IN THE CLAIMS

REMARKS

Reconsideration is respectfully requested for Claims 1-15, the specification and claims having been, respectively, objected to or rejected under 35 USC 112. This objection and rejection of Claims 1-15 is respectfully traversed.

SKETCH "B"

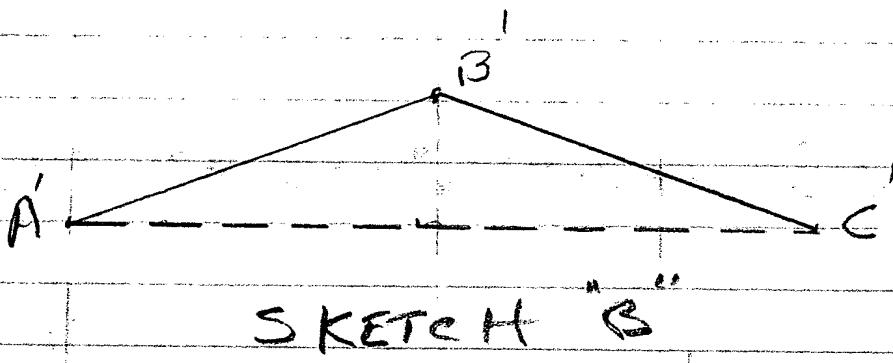
As shown in the second version of a triangle on the attached Sketch "B", the triangle is shown as having vertices A', B' and C'. If the vertex A is held stationary and the vertex B is moved down (by rotating the shaft 14 in FIG. 2), as shown by the vertex B', the distance A'C' is made greater than the distance AC. This concept is the same as that which is illustrated in FIG. 2 of the present application. By moving the vertex B' even further down, until it coincides with the dotted line A'C', the distance A'C' is made even greater. Except for the case when the vertex B moves down to coincide with the dotted line A'C', the dotted line A'C' will always be greater than the combined lengths of solid line AC, merely because a straight line is always the shortest distance between two points.

SKETCH "C"

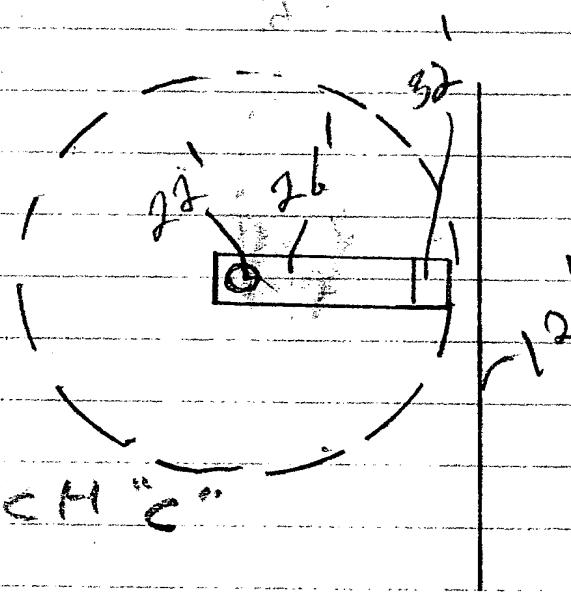
A third Sketch "C" is also enclosed, showing the effect of rotating a beam such as beam 26, in which the beam 26', which is used to pick up load 32', is rotated around a point 22'. Because the nature of rotating beam 26' follows a circular path having a given radius, the load 32' would also follow a circular path and not provide the desired result of keeping the load 32' away from the interior side walls 12' of an enclosed truck such as a van.
